ADDENDUM NO. 1
TO
SPECIFICATIONS
FOR THE
GLOUCESTER CITY BOARD OF EDUCATION
CONTRACT #06 – MEDIA CENTER AND MAIN OFFICE ALTERATIONS
AT
GLOUCESTER CITY MIDDLE SCHOOL

Gloucester City Board of Education
1300 Market Street
Gloucester City, NJ 08030

LAN Job #2.20457.06
January 10, 2024

1 1ST FLOOR FIRE PROTECTION PLAN
FP.01 1/8" = 1'-0"

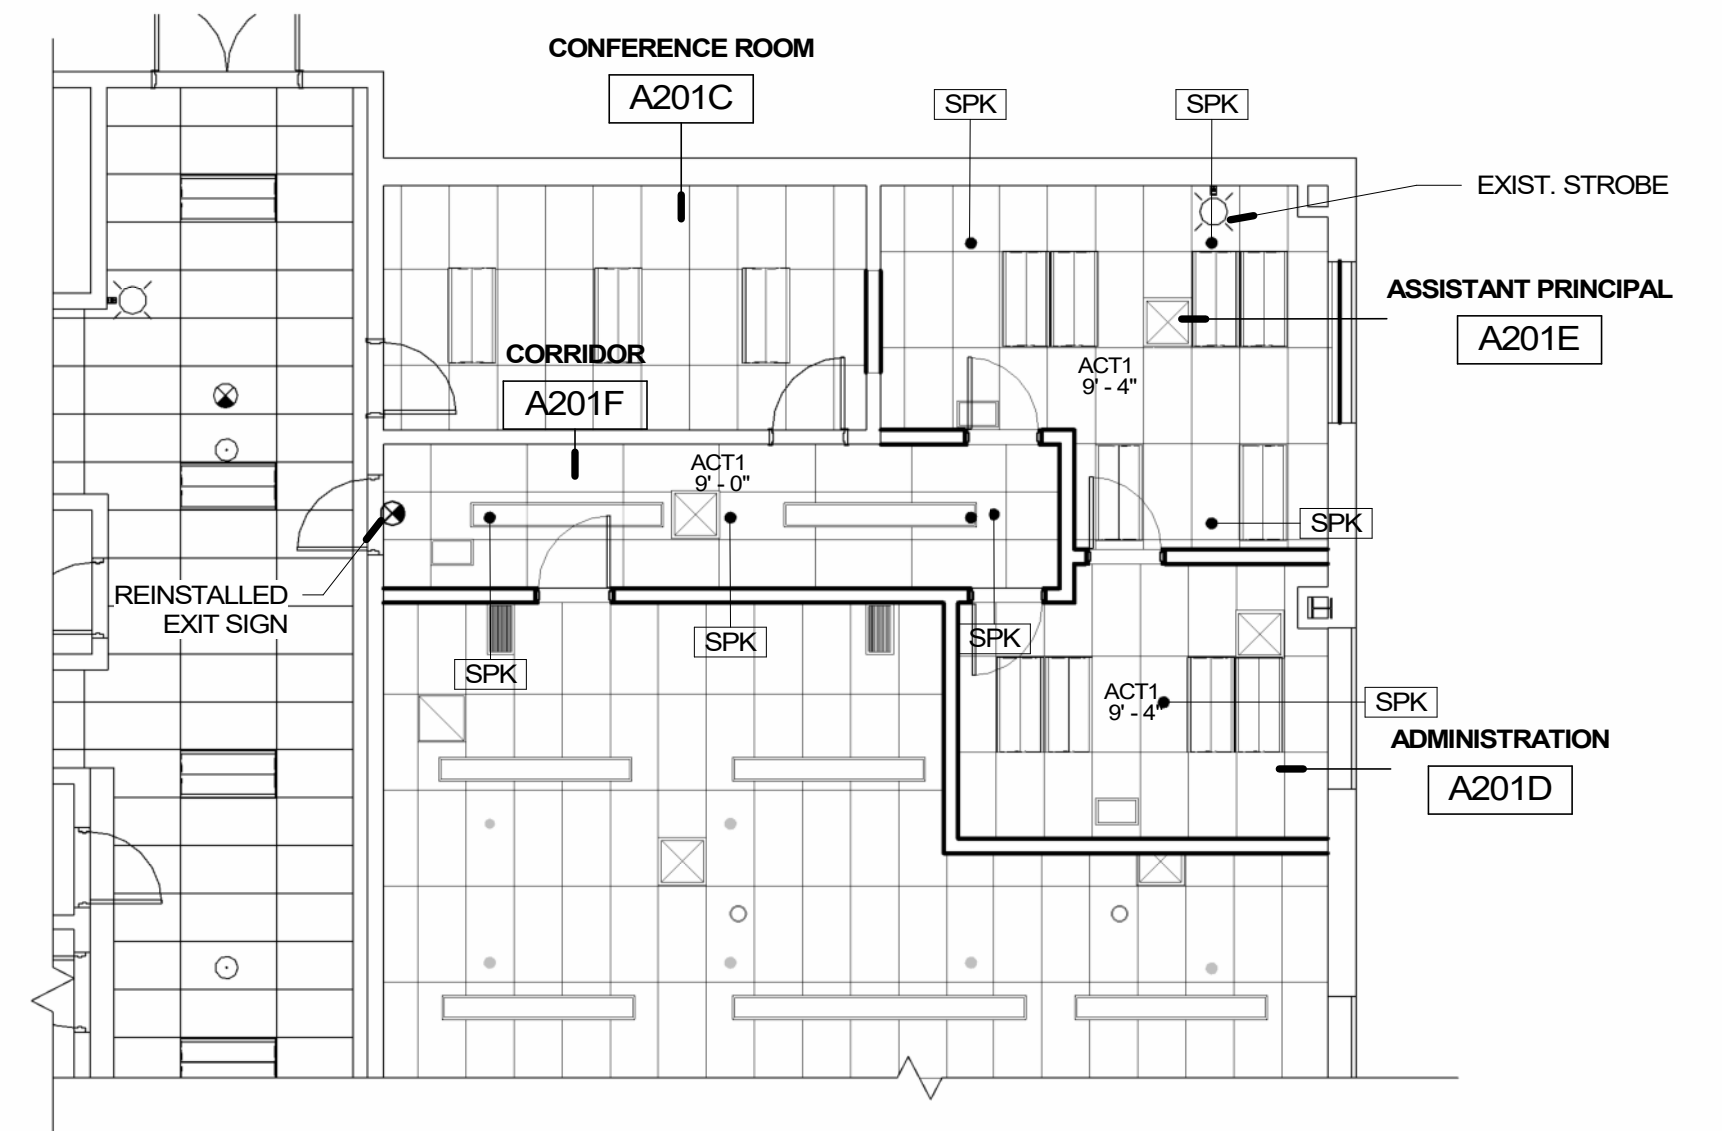
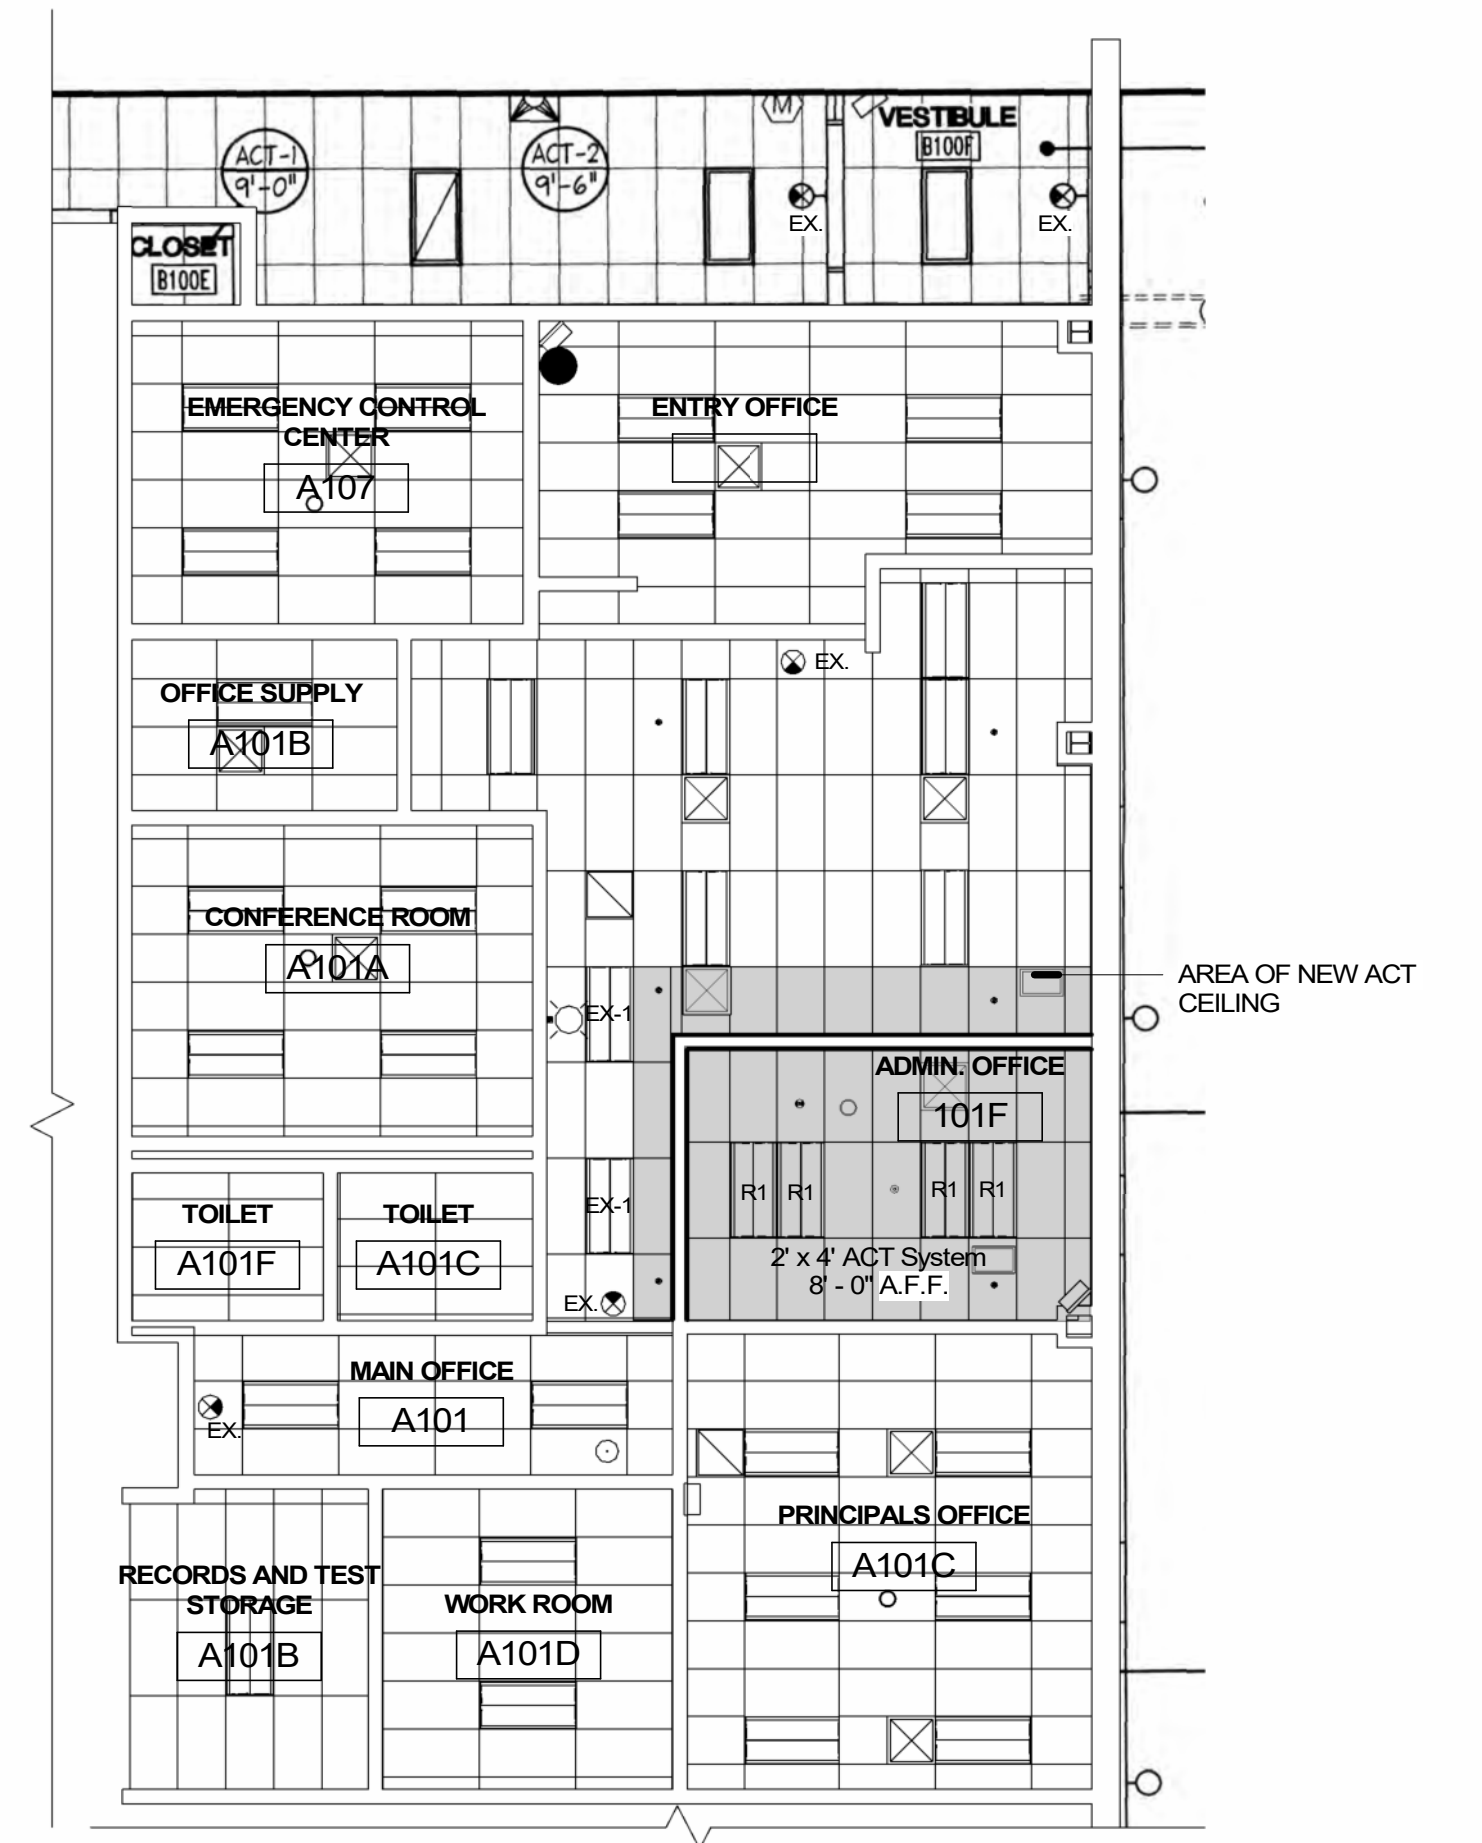
FP.01	ENCLOSURE #5, Drawing Sheet FP.01 'FIRE PROTECTION PLAN' ADDED to show the scope of relocating the existing sprinkler heads.

7. Q: On A1.01, it tells us to remove sprinkler heads. I do not see new heads on the new RCP. Are we only demolishing the heads, or do they need to be reconfigured for the new layout?

A: The NFPA 13 sprinkler system will have to be altered to provide coverage for the new room configuration. See Enclosure #5, Drawing Sheet FP.01 'Fire Protection Plan'.
